SANDY SPRINGS
GEORGIA

P&Z STAFF REPORT

Board of Appeals Meeting, December 10, 2019

Case: **V19-0022 – 0 Glenridge Drive**
Staff Contact: Madalyn Smith (msmith@sandyspringsga.gov)
Report Date: December 3, 2019

2
AA1.19B
SECTION AT ALT. SERVICE DRIVE AISE - D.C.8.1.10.C.3
SCALE: 1/8" = 1'-0"

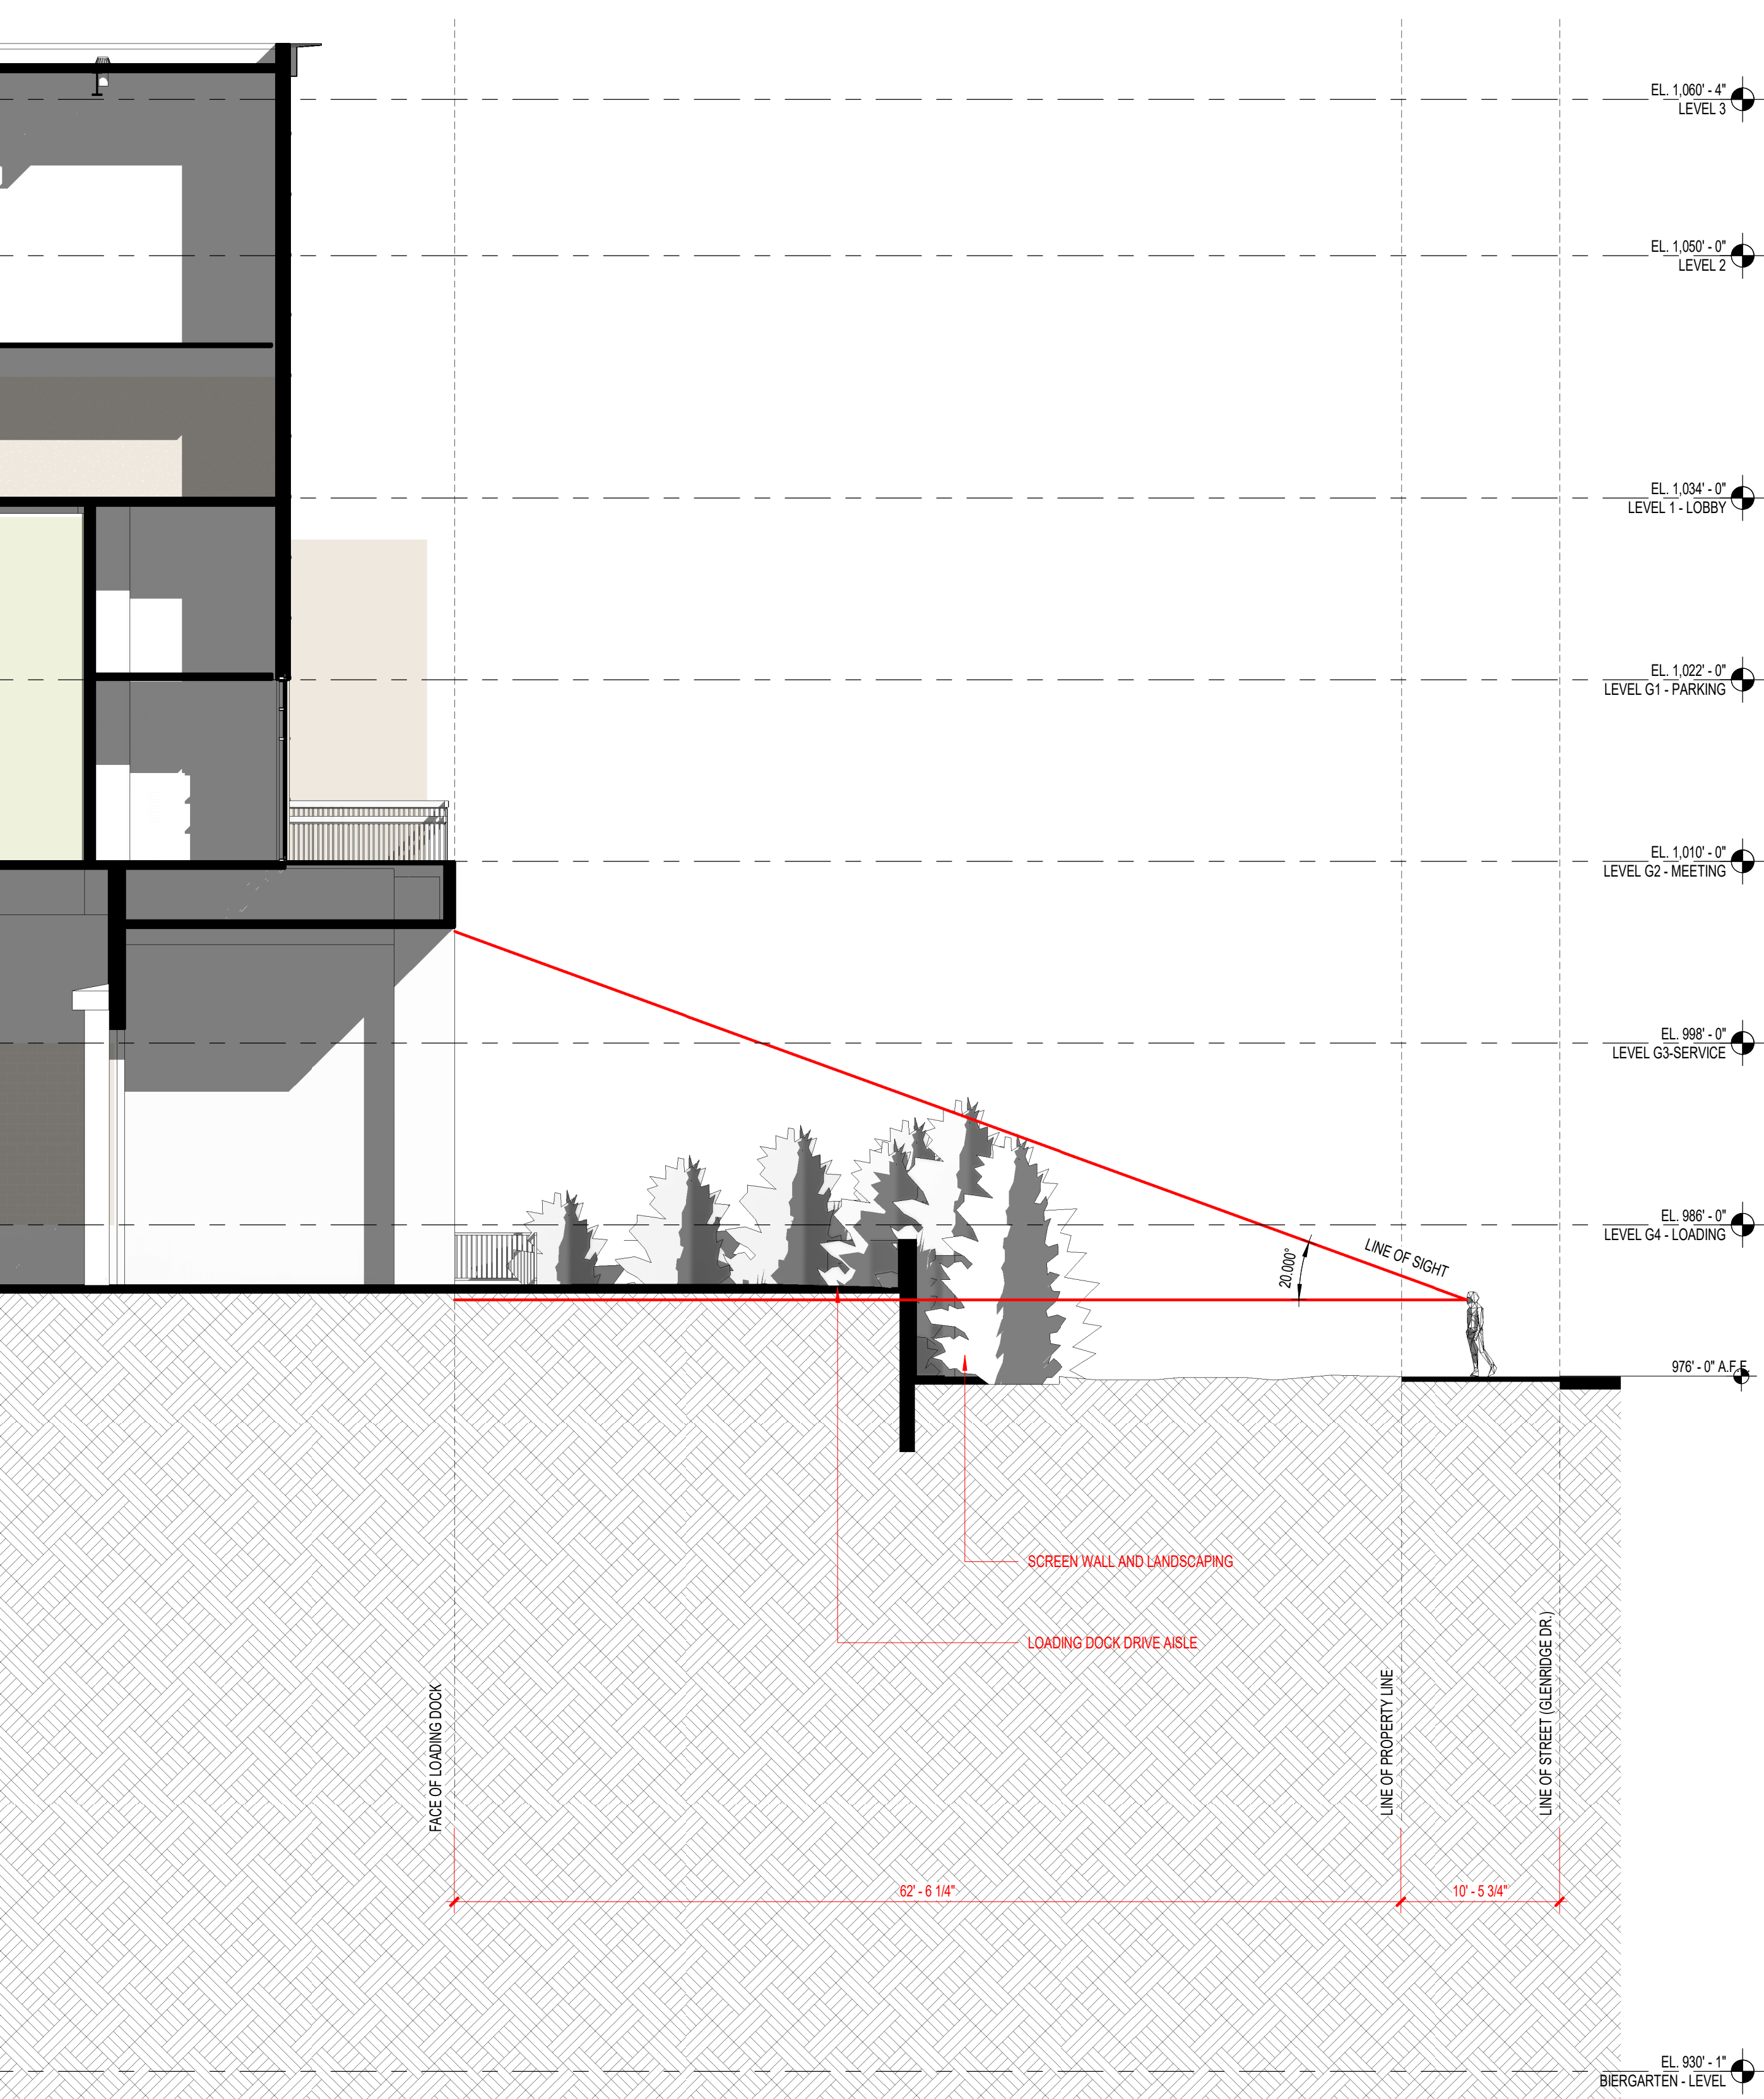
There are extraordinary and exceptional conditions due to the shape and topography of the site. While the lot is fairly large at 5.2 acres, it is only around 200 feet wide. Much of it is unbuildable due to the presence of state waters, floodplain, and wetlands. The portion that is buildable, is a large, steep hill. The narrowness of the property and the topography limit the options for placement of the loading dock. Adherence to this section of the Development Code would require the loading dock to be placed to the rear of the building, which would not eliminate a Variance request because accessing the rear would require the construction of retaining walls ranging from 10-20 feet in height. The retaining walls would require a Variance from either the height limitation of 8 feet, or if the wall is tiered it would require a Stream Buffer Variance. As noted by the City architect, it would also put the loading dock activities adjacent to residential uses. The applicant proposes to locate the loading dock in the most logical place on the site. Therefore, staff recognizes a hardship.

The location and orientation of the loading dock also seems to be the only practical solution. The alternative location appears to create much more site disturbance, create difficult access issues and put the loading dock activities directly adjacent to a residential use.

1. The location of the loading dock be substantially similar to that shown on the “*Mayson House Variance Issuance*” plans received October 28, 2019 and subsequent amendments received November 6, 2019.
